**Planning & Development Division**  
Planning & Economic Development Department

File Number	PL 20-151	Contact	Kyle Deming, <a href="mailto:kdeming@duluthmn.gov">kdeming@duluthmn.gov</a>	
Type	Variance – fence setback, height, and transparency	Planning Commission Date		October 13, 2020
Deadline for Action	Application Date	September 15, 2020	60 Days	November 15, 2020
	Date Extension Letter Mailed	October 6, 2020	120 Days	January 13, 2021
Location of Subject		460 Jean Duluth Rd. (Hunters Park)		
Applicant	Paul Miner	Contact		
Agent	Hanft Fride P.A.	Contact	William Burns/Terri Crossmon	
Legal Description		See attached (010-3330-01520)		
Site Visit Date	October 2, 2020	Sign Notice Date		September 29, 2020
Neighbor Letter Date	October 2, 2020	Number of Letters Sent		28

PL 20-151  
460 Jean Duluth Rd.  
Fence Variance

Boundary Survey of Lots 14, 15, 16, 17, 18, and part of vacated alley adjacent, Block 15, Re-Arrangement of Morley Heights First Add'n, Section 12, T50N, R14W, St. Louis County, MN  
For: Paul Miner

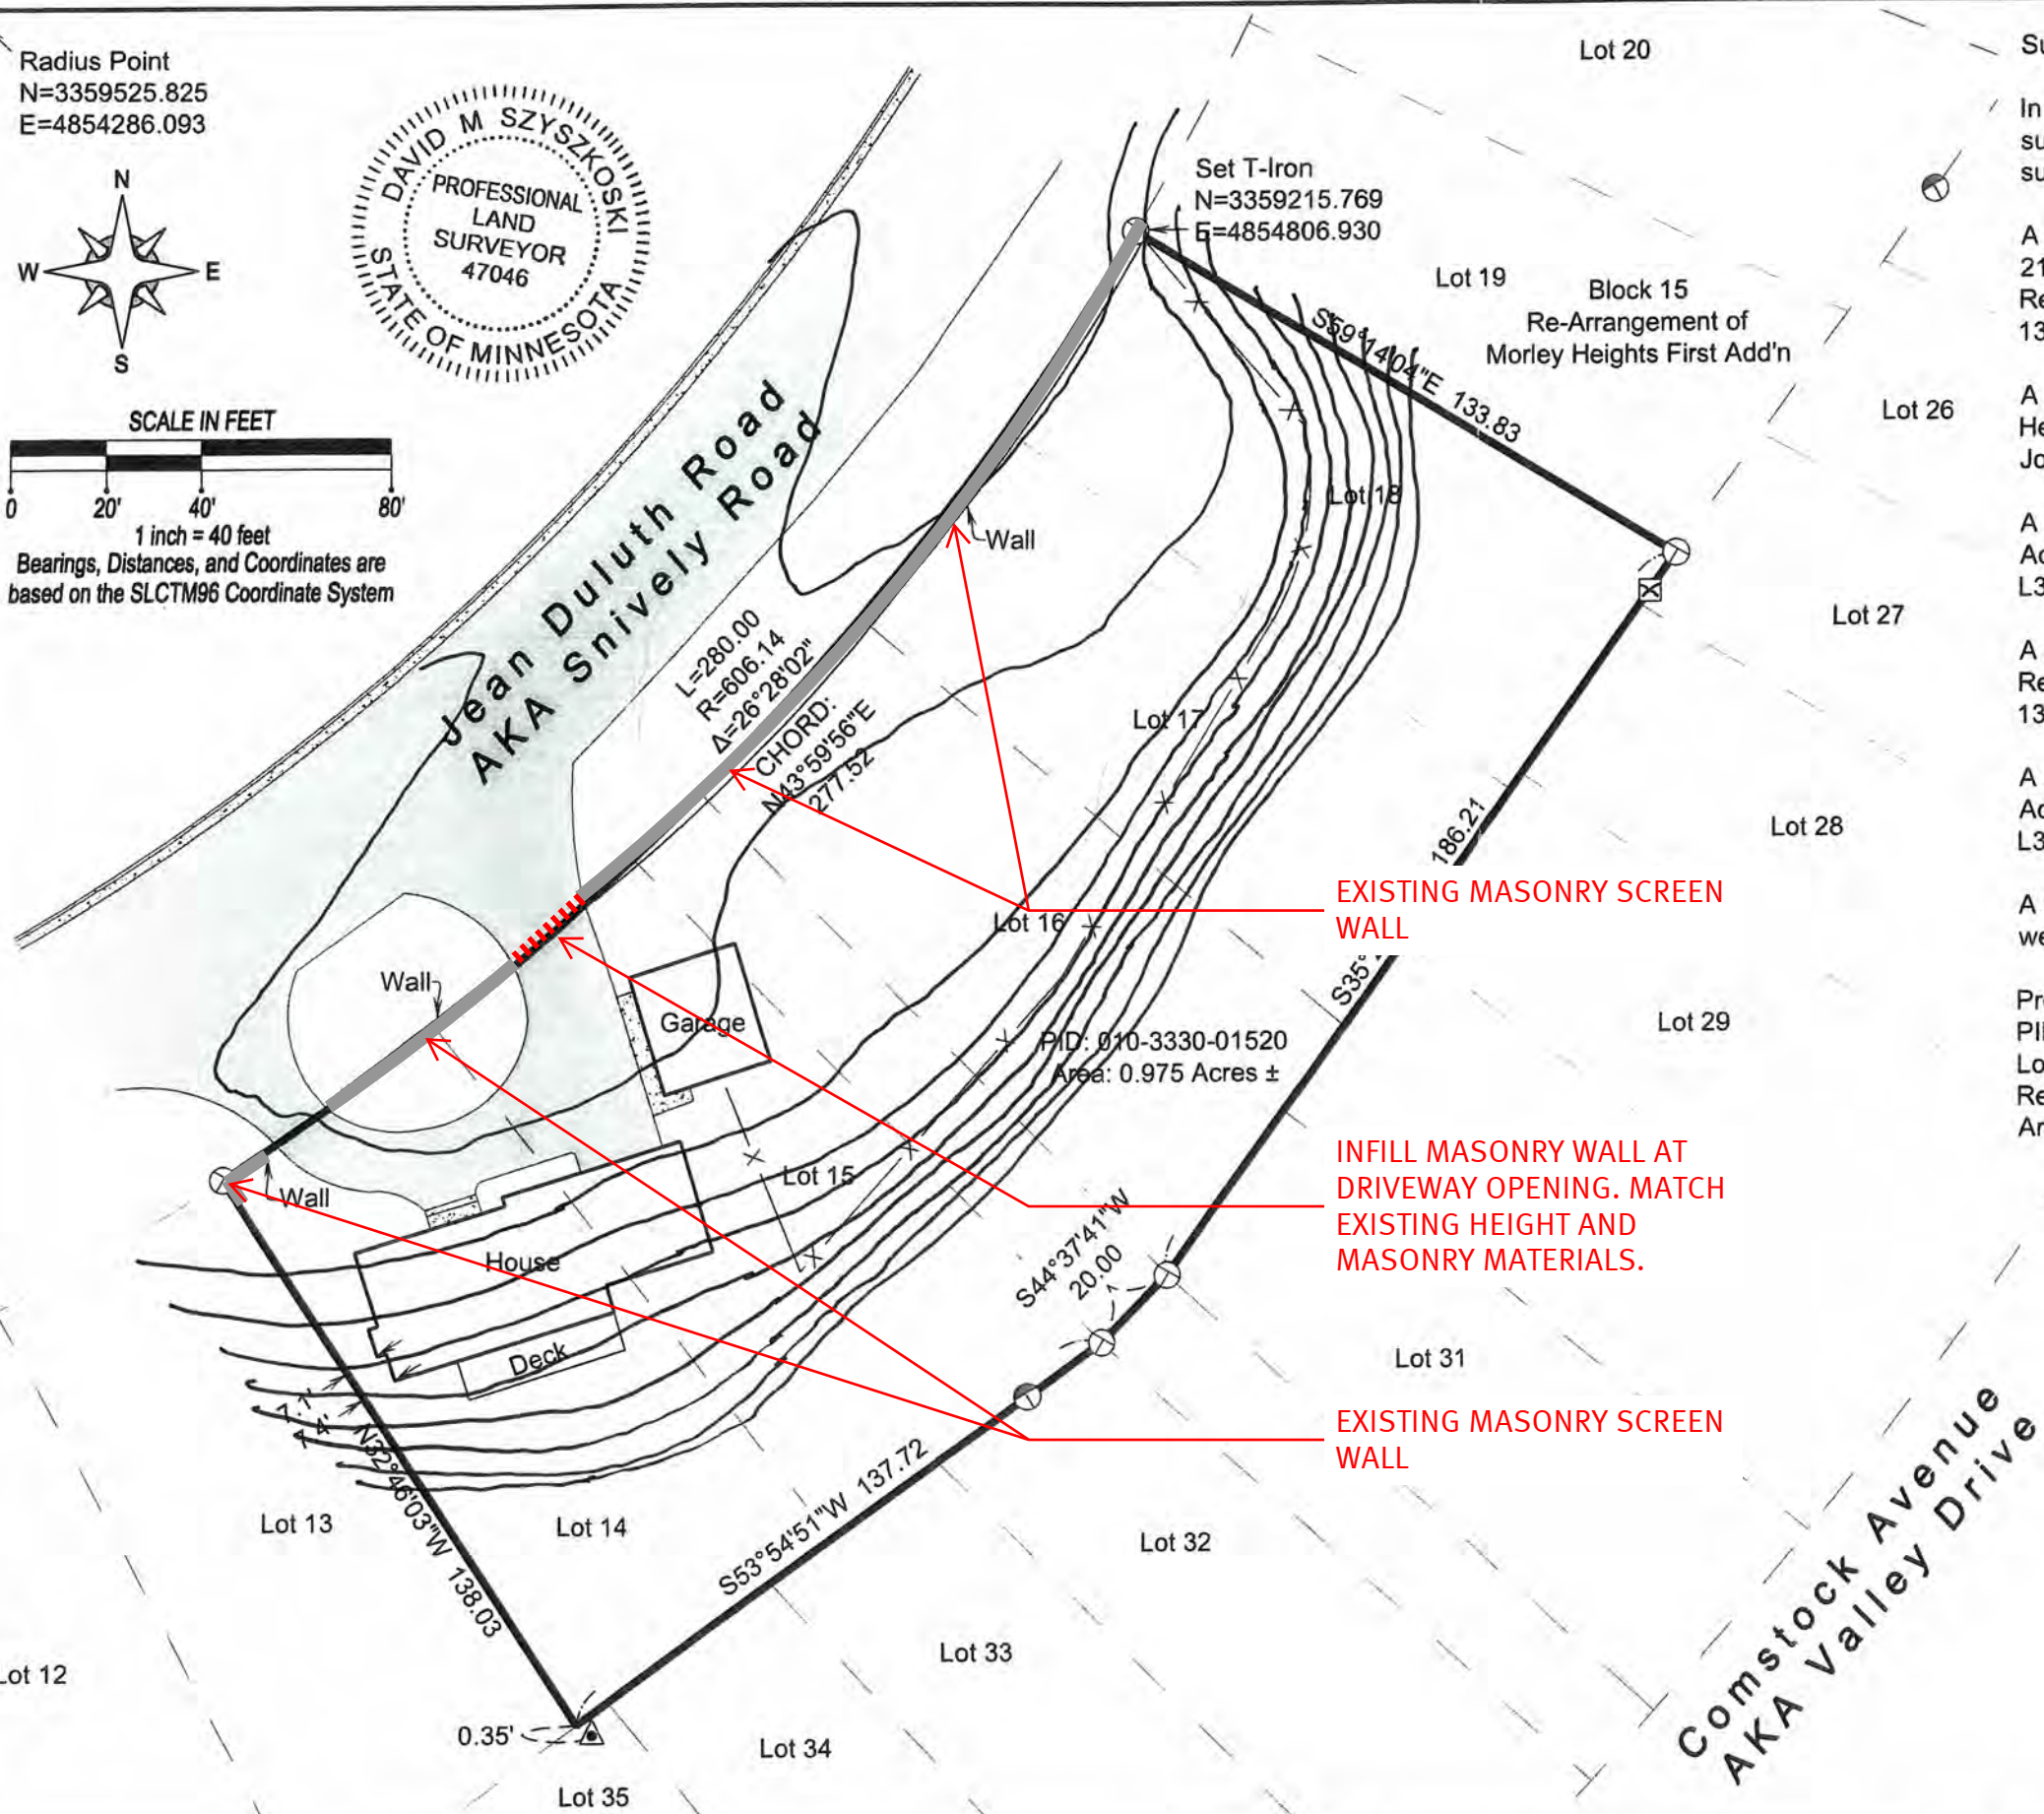
- 1) The applicant’s dwelling and yard is separated from Skyline Parkway by masonry fence built at the street easement line that is 5 feet – 8 inches tall. This fence has two gaps in it that allow access via a semi-circular driveway and the proposal is to close off one leg of the driveway and to infill the wall at the same height and in alignment with the existing, legal nonconforming fence.

INFILL MASONRY  
WALL AT DRIVEWAY  
OPENING. MATCH  
EXISTING HEIGHT  
AND MASONRY  
MATERIALS.
